# **Columbia River Channel Improvement Project**

Final Supplemental Integrated Feasibility Report  
and Environmental Impact Statement

Comment Letters on the Draft  
SEIS and Corps Responses

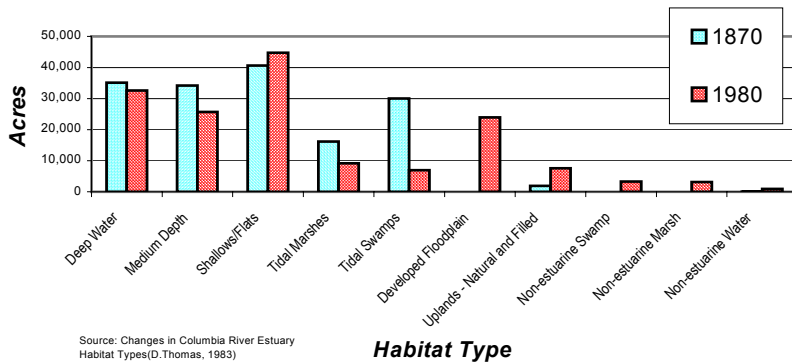
SS-312 The series of ecosystem restoration features taken as a whole, do not negate impacts from the actual deepening and, with the exception of long term Tenasillahe proposal, provide little if any positive benefits to the estuary, and in some cases actually result in ESA species take.

CREST supports the concept of using dredged material for the purpose of restoring habitat. Unfortunately, the two projects presented that involve dumping and that are labeled 'restoration' will result in permanent alteration and further degradation of the estuary. CREST has stated in several forums that the use of dredged material for restoration needs further exploration on an experimental basis with a strong monitoring component similar to the Benson Beach project. Millions of cubic yards dumped over the first two years of construction at Lois and Mott Island embayment is not experimental

SS-312. The series of ecosystem restoration features were not derived to negate impacts from the channel improvement project. Rather, through the ESA reconsultation process they were developed under Section 7(a)(1) of the Endangered Species Act, wherein federal agencies utilize their authorities for the benefit of listed species. They are not mitigation actions, a common misconception.

The Corps disagrees with your opinion that the proposed ecosystem restoration features provide little, if any, positive benefits to the estuary. The ecosystem restoration features proposed represent an array of efforts that will result in limited (individual tidegates) to extensive (Tenasillahe Island long-term feature) estuarine and lower Columbia River benefits. These proposed features represent actions that are readily implementable in concert with the channel improvement project.
